PRAIRIE ISLAND NUCLEAR GENERATING PLANT, UNIT NO. 1

AMENDMENT TO FACILITY OPERATING LICENSE

Amendment No. 82  
License No. DPR-42

ATTACHMENT TO LICENSE AMENDMENTS NOS. 82 AND 75  
FACILITY OPERATING LICENSES NOS. DPR-42 AND DPR-60  
DOCKETS NOS. 50-282 AND 50-306

FIGURE TS.6.J-2 PRAIRIE ISLAND NUCLEAR GENERATING PLANT FUNCTIONAL ORGANIZATION FOR ON-SITE GROUP

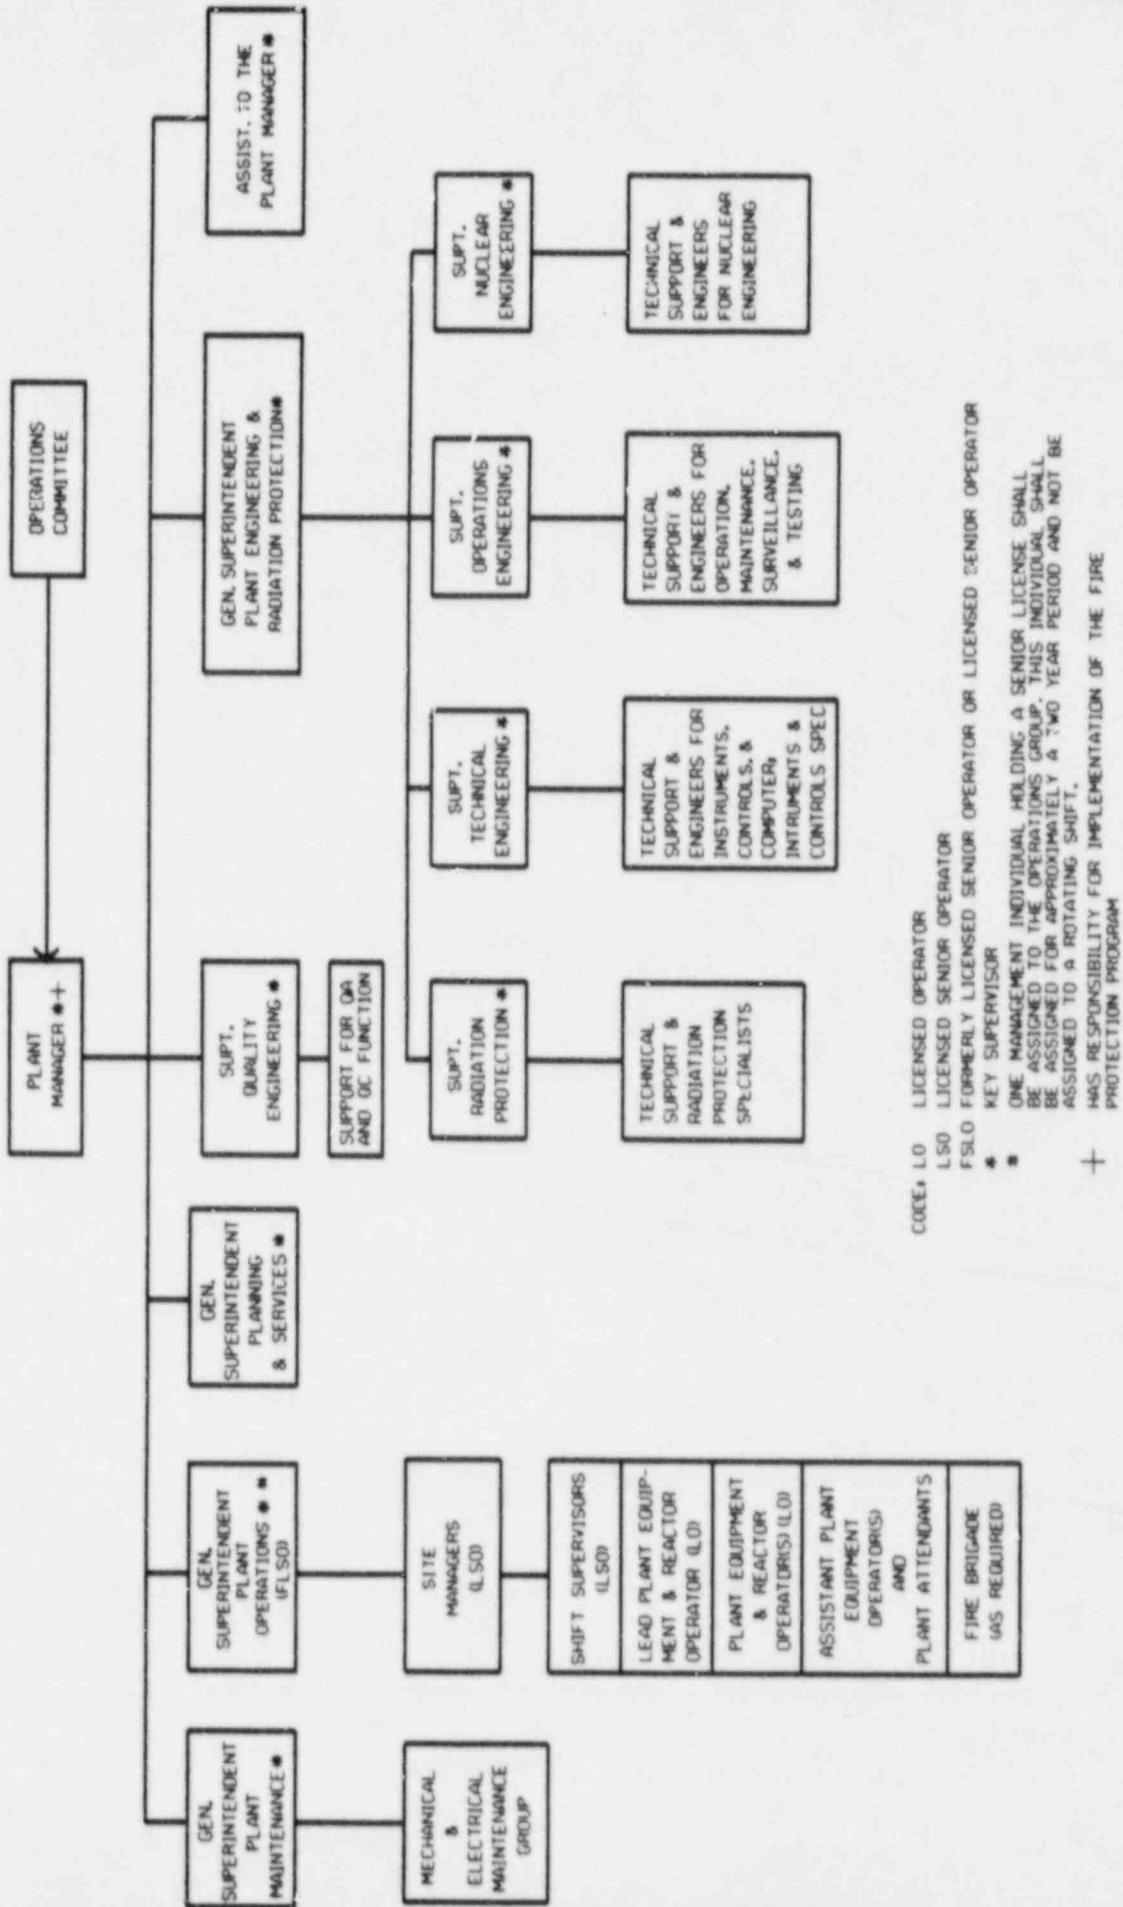
Revise Appendix A Technical Specifications by removing the pages identified below and inserting the attached pages. The revised pages are identified by amendment number and contain marginal lines indicating the area of change.
